Product Change Notification

Date Issued :	July 05, 2023	PCN Number :	513974
Reason for Change :	Equipment Transfer, Production Transfer or Rearrangement		
Description of Change :	This notification is to inform you about an mold transfer that has been issued to manufacture impacted part(s). Mold has been moved to different site/ location/ premises. No changes will be made to product as part of this change.		
Assessment of Change :	No change to parts - Form/Fit/Function		
Planned Implementation Date :	January 05, 2024		
Sample Availability Date:	November 13, 2023		
Internal Molex Qualification Date :	November 13, 2023		
Last date to request Samples by Customer :	December 22, 2023		
Traceability Code Markings / Date :	Date code

Guadalajara 2

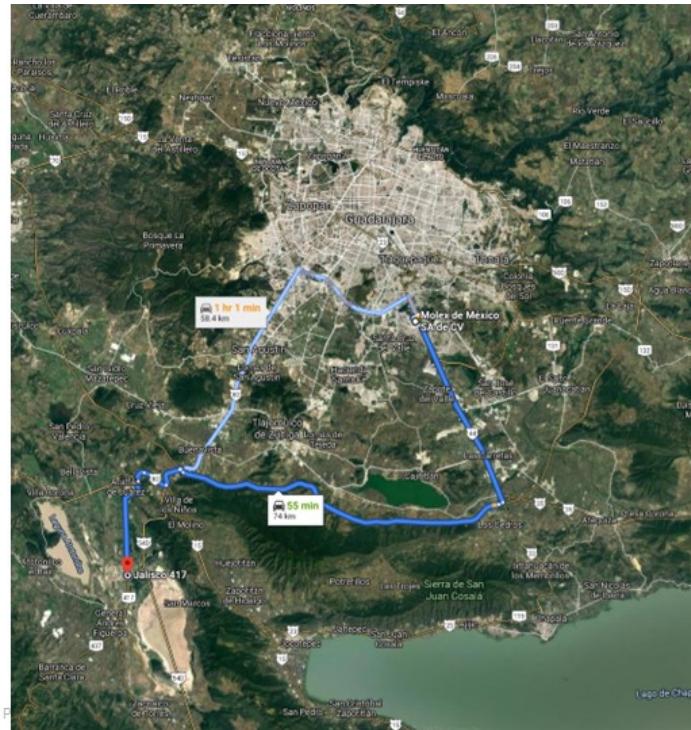
- Located in Centro Logistico Jalisco Industrial Park
- 1 hour from existing Guad1
- Initial build will contain Molding, Assembly, and Reliability Testing capabilities
- A new Distribution Center services Guad2
